# CITY OF CONWAY, ARKANSAS HISTORIC DISTRICT COMMISSION

# 136 Oliver Street - Addition & Renovation

Old Conway Design Overlay District

136 OLIVER STREET ADDITION  
 ARCHITECTURAL SITE PLAN

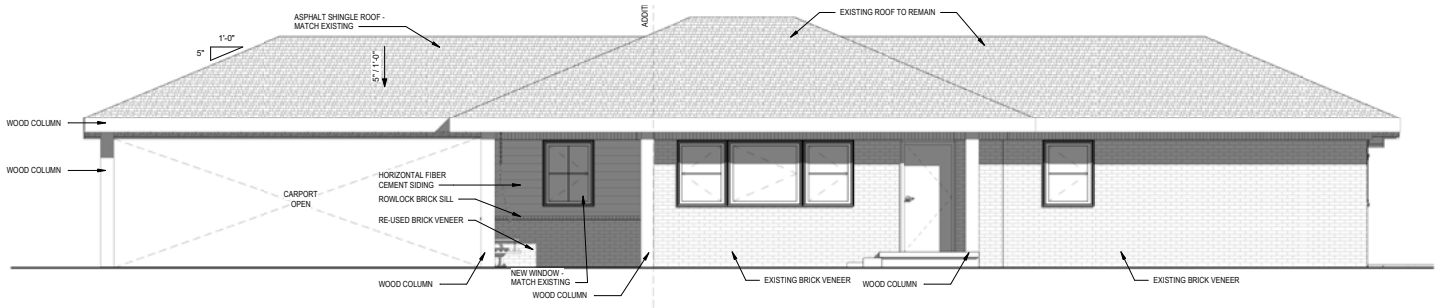
*Additions include the infill of an existing carport and construction of a new, 2-vehicle carport that recedes approximately 6' from the established setback distance of the single-family residence from the street. The carport addition is more than 6' from the side property line.*

**Parking.** Parking is not permitted in the front yard of houses. Parking is allowed in driveways. No more than 50% of the front yard may be paved. Parking areas should be concrete, pavers, or permeable parking surfaces such as grass pavers. Two (2) parking spaces per dwelling unit are required.  
*Proposed carport will provide two (2) covered parking spaces and the proposed ribbon driveway will provide additional parking.*

**Driveways.** Driveways should be concrete, pavers, or permeable parking surfaces such as grass pavers. Historic driveways such as concrete strips with a grass median are encouraged.  
*Applicant proposes to realign the existing driveway to provide access to the new carport. Proposal is a concrete ribbon driveway.*

1 PROPOSED FRONT ELEVATION  
1/4" = 1'-0"

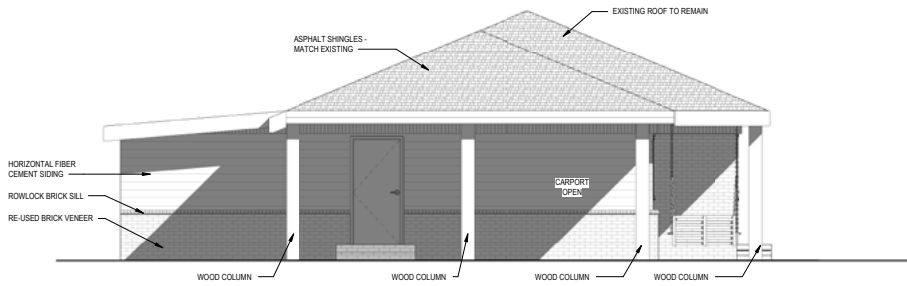
**Façade, wall area, rhythm.** New facades shall be compatible with those of the surrounding area. 25-40% of front façades should contain windows. Window and door openings should relate to the size and proportions contained in the surrounding area.  
*Remodel will not alter the façade, wall area or rhythm of structure in relationship to those in the neighborhood. Over 25% of the front façade is windows/doors. Carport infill includes a window which matches the size, type and orientation of other windows along the front façade.*

**Entries, Porches, and Porticos, Doors and Windows, Awnings.** Windows should be of divided-light construction, where divided-light windows are proposed. Fake muntins are not permitted. Roofing for porches should match the main structure.  
*Applicant will replace metal posts with wooden posts along front porch and new carport. Wooden posts are of a simple design that does not create an anachronistic appearance. Proposed window is the same brand and style as existing.*

2 PROPOSED SIDE ELEVATION  
1/4" = 1'-0"

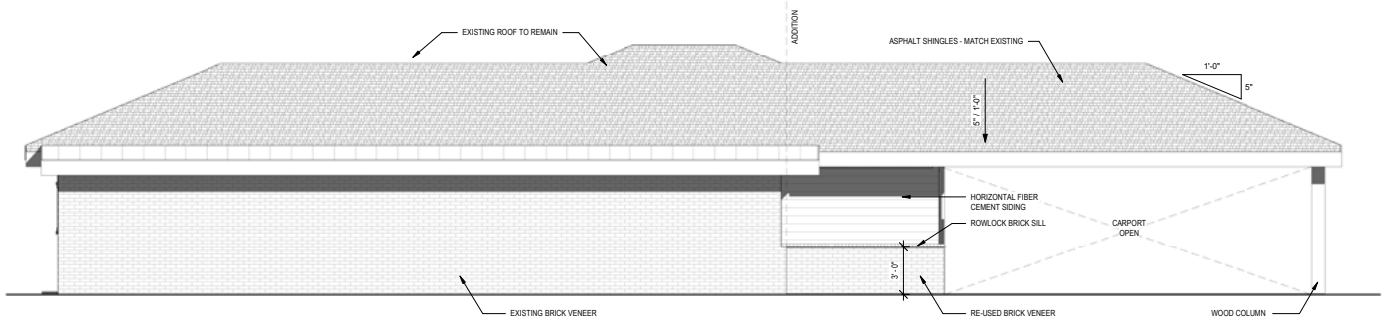
**Architectural Details, Siding, and Bricks.** Detailing and siding should complement the surrounding area. Siding should include brick, stone, wood, or Hardie® siding/LP® SmartSide® type siding.  
*The exterior of the addition will have brick to match the existing residence. Hardie® siding is proposed for the upper portion of the addition.*

**Shutters, Roof, Decks/Plaza Space, Skylights, Mechanical Screening.** Roofing should respect the character of the surrounding area with respect to materials, pitch, and form. Metal roofing is prohibited unless historically used on the structure.  
*Carport shingles will match existing.*
